WHITE PLAINS CITY SCHOOL DISTRICT

RENOVATIONS AT ROCHAMBEAU ALTERNATIVE HIGH SCHOOL
SED Control Number: 66-22-00-01-0-015-020

CLARIFICATION TO PROJECT:

DRAWING No.
A 200.00

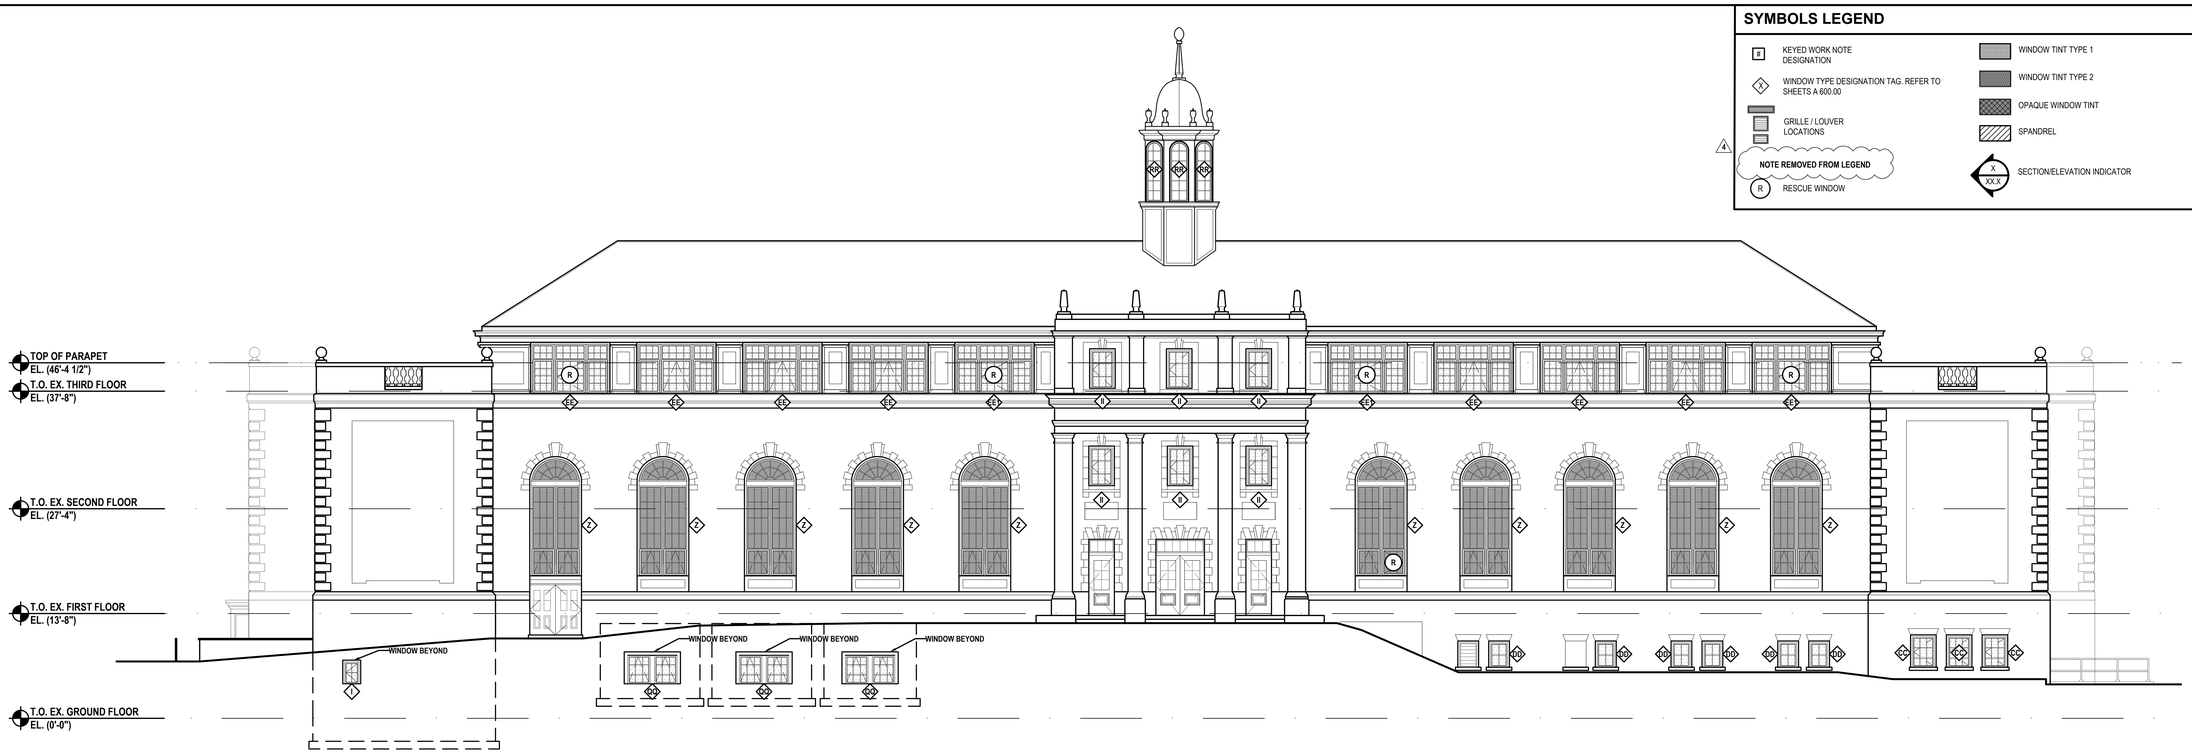
2. *[On A200.00] Note 11 indicates the following: "Rake out existing Joint between stone coping, fascia, sill, base, Pediment and brick to a min depth of 1 inch. Furnish and install new mortar joint to match existing stone. All stone surfaces to be sealed at completion of repointing. Skyward facing joints pointed with sealant."*

- *Currently, there are no notes on the elevations indicating which building components/elements are to be included in this scope, so it is impossible for us to properly price the stone repointing without clear distinction on the drawings for quantity to be included.* **This particular scope of work is at the joints at the window stone sills only. Single wide windows do not have joints but any window system, 2 units or more, have joints in the window stone sills. See photo attached for reference.**

3. *Symbols legend on building elevations indicates a hash symbol for "Brick/Stone area to be repointed, see key note 1" however, this hash/symbol does not appear anywhere on the elevations. If this hash/symbol was used for all areas that are to be included in the Note 11 scope, this would allow us to accurately price and define this work scope.* **Symbol removed from legend. See item 1 for repointing clarification.**

- *The masons we have spoken with have also requested repointing details.* **Typical repointing elevation added to sheet A501. Note 11 on A200-A202 delineates the scope of work for the repointing.**

1. Remove A 200.00 SOUTH & WEST ELEVATIONS and replace with A 200.00 SOUTH & WEST ELEVATIONS. Brick repointing hatch removed from legend. Note 11 on General Notes has been revised.

3 Plumbing Enlargement Plan of Room 322

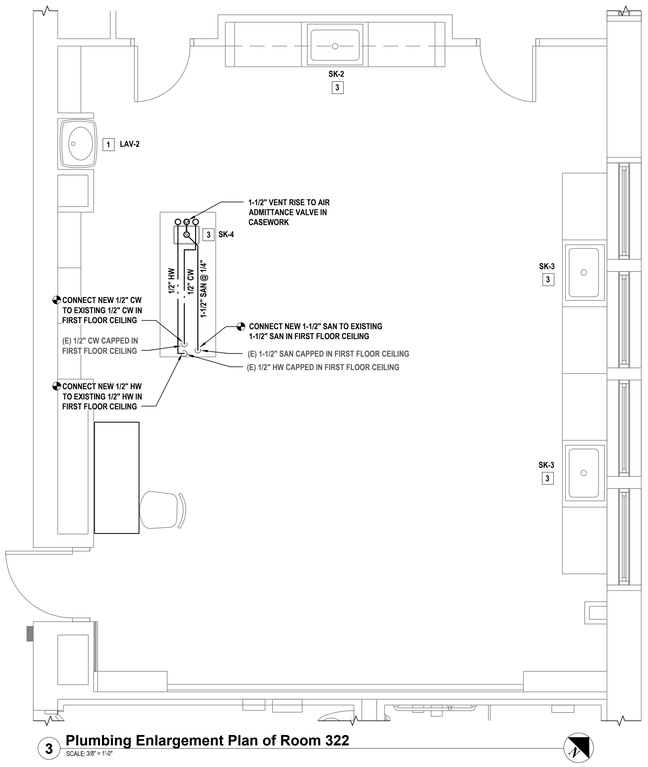
15. *Considering that there are acid neutralizers under the lab sinks in Room 322 is the glass acid waste piping required downstream of the neutralizers?* **No neutralizers are required since there will be no chemicals in this room. There are sediment traps under the sinks. See revised plumbing drawings in this addendum.**

6. Remove P100.01 PLUMBING ENLARGEMENT PLANS AND RISERS and replace with P100.01 PLUMBING ENLARGEMENT PLANS AND RISERS. Key Plumbing Notes revised.

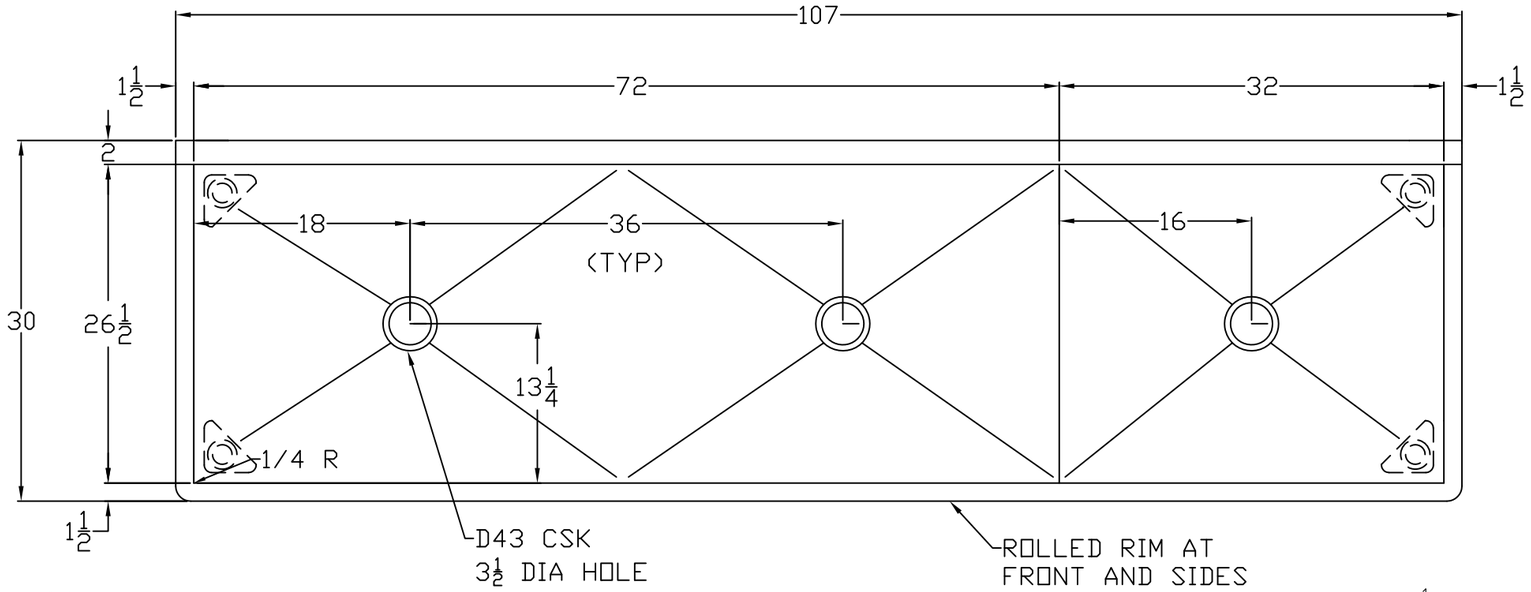
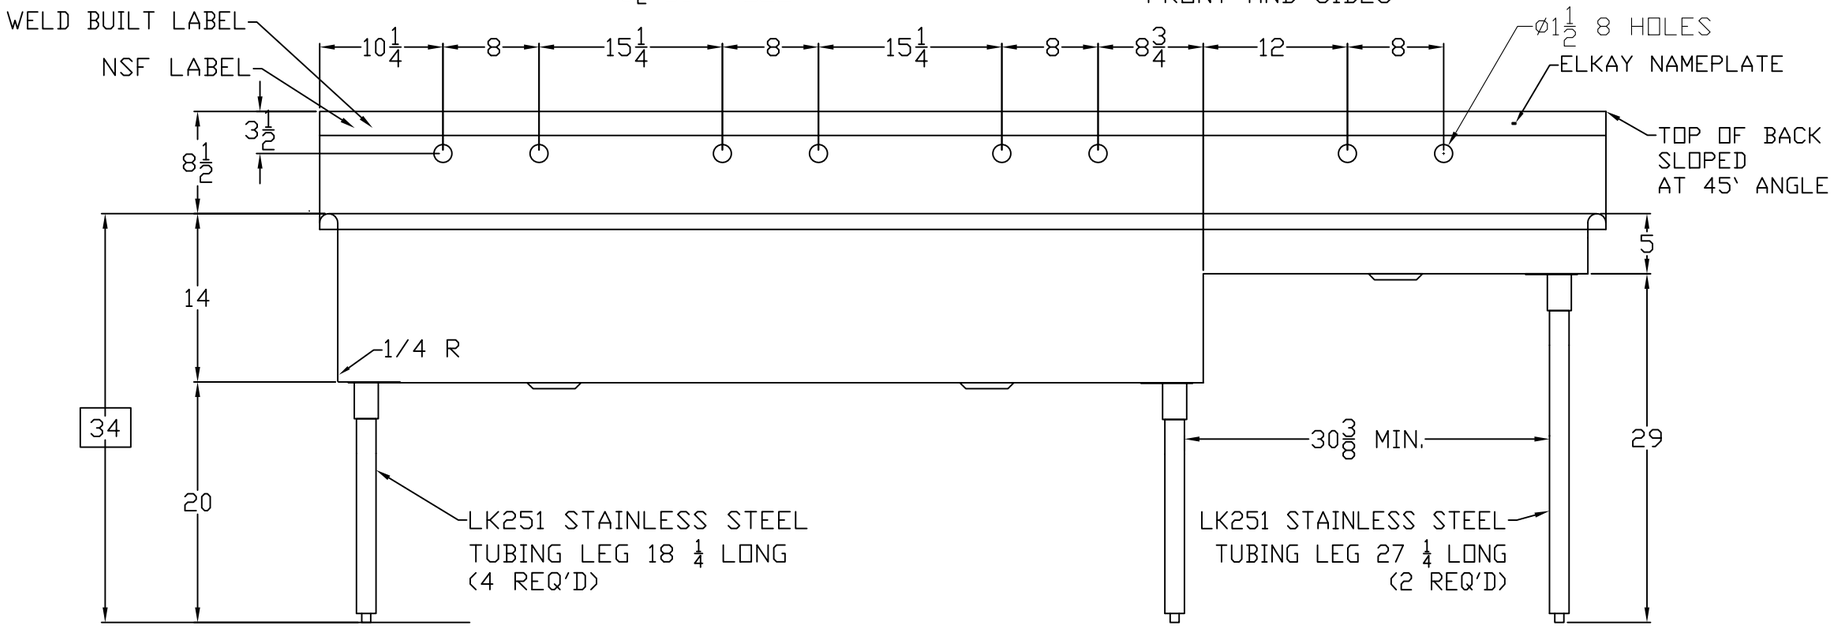
14. *SK-1 Art Room Sink is a custom sink. Elkay needs a sketch before they will provide a price according to our supplier. Please advise.* **Cut-sheet of sink attached to this addendum.**
